IN THE UNITED STATES PATENT AND TRADEMARK OFFICE

Serial No.: 10/006,171

INDUCTIVE POWER SOURCE FOR PERIPHERAL DEVICES

RESPONSE TO OFFICE ACTION

Replacement Sheet

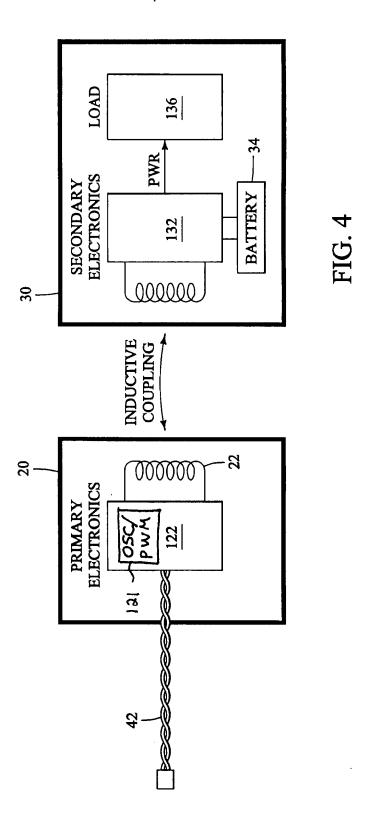
The drawings are objected to for failing to show various features recited in the claims. Applicant traverses this objection.

An embodiment of an "oscillator circuit" as recited in claim 19 is shown as item 121 in revised Fig. 4. Support for this drawing revision may be found in the specification at page 9, lines 13-16.

An embodiment of a "pulse width modulation circuit" as recited in claim 29 is shown as item 121 in revised Fig. 4. Support for this drawing revision may be found in the specification at page 9, lines 13-16.

Attached is a proposed Replacement Sheet showing a revised Fig. 4. Also included is an Annotated Sheet showing in detail the changes made.
